Stannah Lifts Technical Bulletin

Issue No:E 11

LIFT TYPE

System 21 lifts. Manufactured prior to 1995.

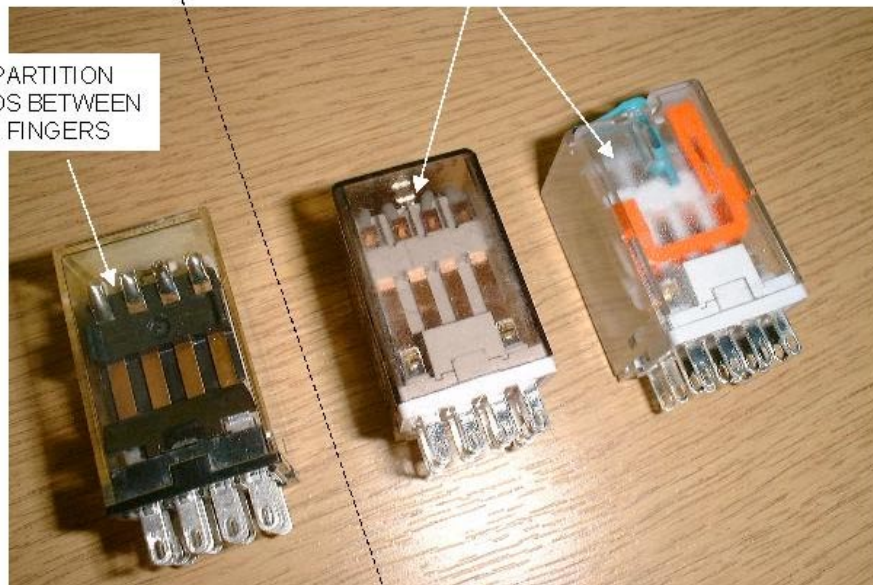
We have recently experienced a fault that occurred on a 12 year old traction lift, fitted with a Generation 1 controller. The ACR relay was found to have a short circuit within the relay connecting pins 9 and 10. The effect of the fault caused the gate lock circuit to be bypassed and created the possibility for the lift to travel with the doors open under certain test control conditions.

Through investigation and risk assessment we have identified that this fault has occurred on a very early version of IMO relay that may be found on lifts manufactured before 1995 (this is identified within the door of the control cabinet). The later versions, supplied by IMO, include additional arcing shields at the top of the 'fingers' that reduce the risk of this fault ever occurring. Therefore we request that at the next available service visit, any lift, hydraulic or traction that still contain an ACR relay of the 'older style' should be replaced with a newer version of relay. Please see attached diagram for further information on identification of relay.

ARC SHIELDS FITTED

NO PARTITION
SHIELDS BETWEEN
THE FINGERS

OLDER STYLE RELAY

NEWER TYPE OF
RELAY
